FLD2026-05010
RESPONSES TO LETTER OF INCOMPLETENESS

Project Description and Address:

Carlouel Beach and Yacht Club
1091 Eldorado Avenue
Clearwater, FL

Applicant has reviewed the comments provided by the Development Review Committee (“DRC”) and has responded to each comment below in blue. As part of this re-submittal, Applicant’s design and development team has incorporated each department’s comments into the revised plans and responses which include:

PRE-DEVELOPMENT BASIN MAP

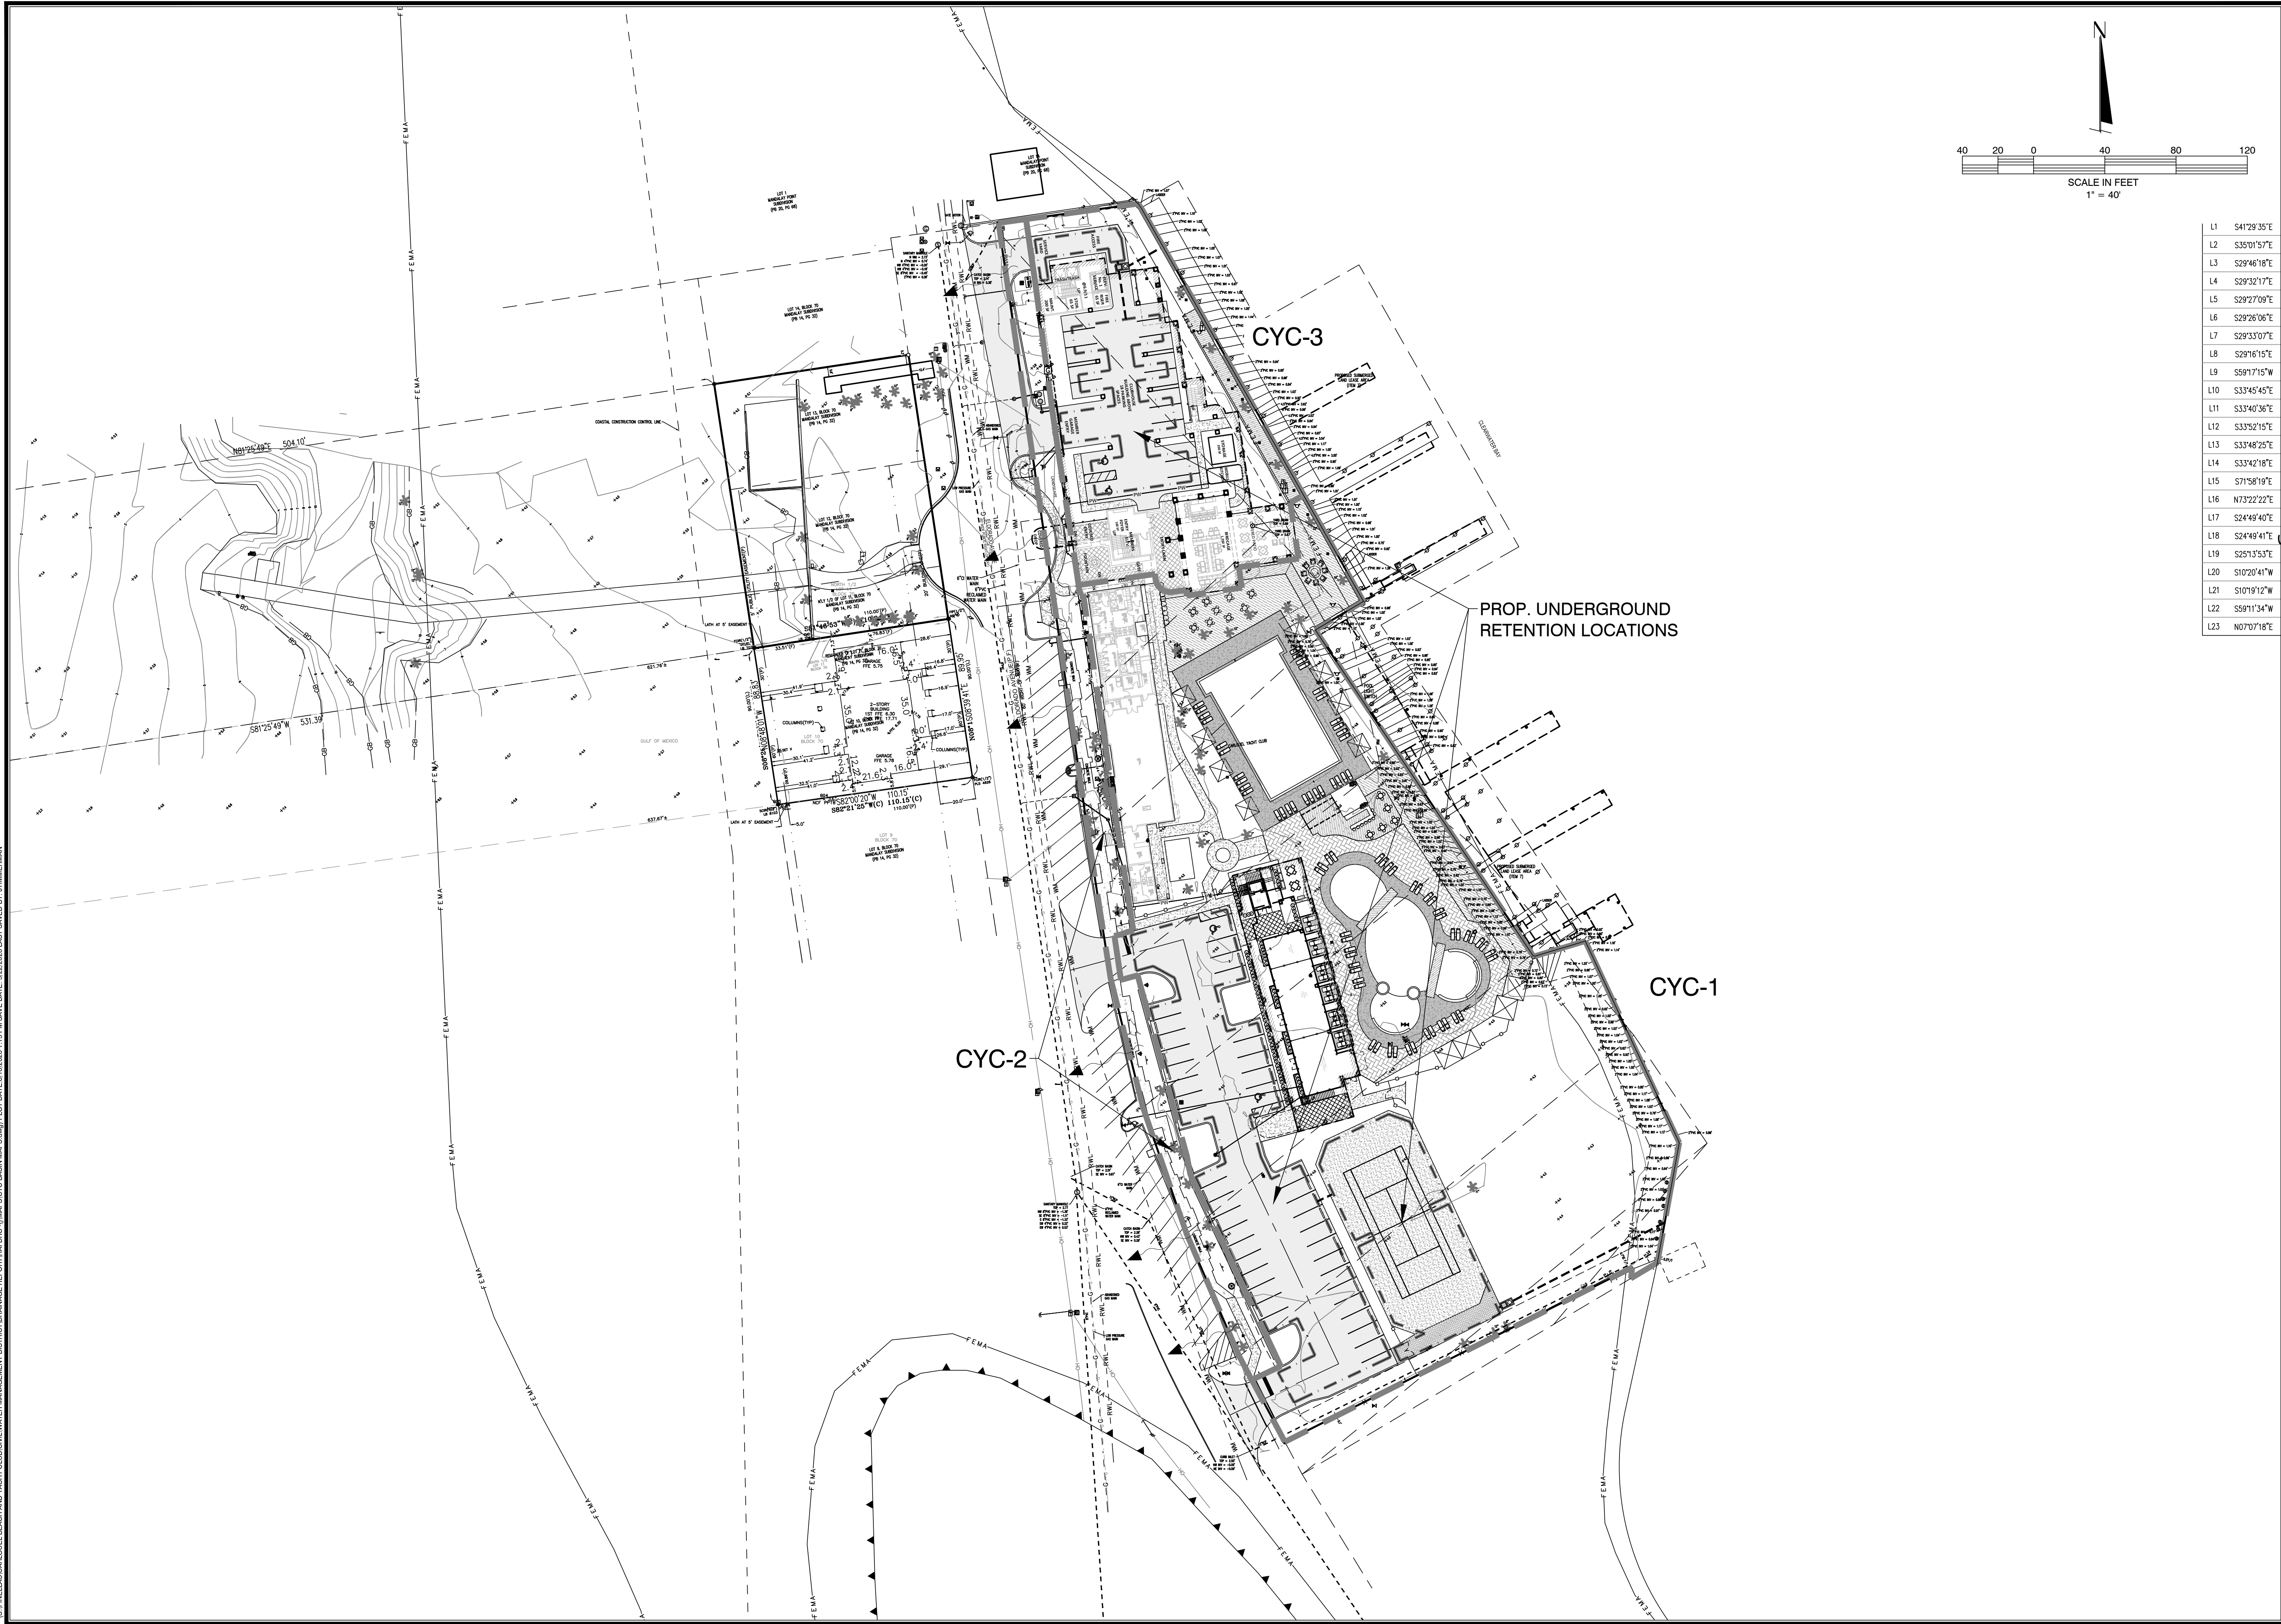
- Pre-development basin map reveals that most of the site's runoff currently does not flow to the city's conveyance systems. Please revise design and drainage narrative/calcs demonstrating attenuation is provided on site to ensure post flow rate does not exceed pre-flow rate at all proposed connections to the city's systems. Please be informed that attenuation will not be required if post discharge outfalls directly to Clearwater Bay through seawall penetration.
 - We will connect directly into Clearwater Bay. Drainage narrative has been revised accordingly.
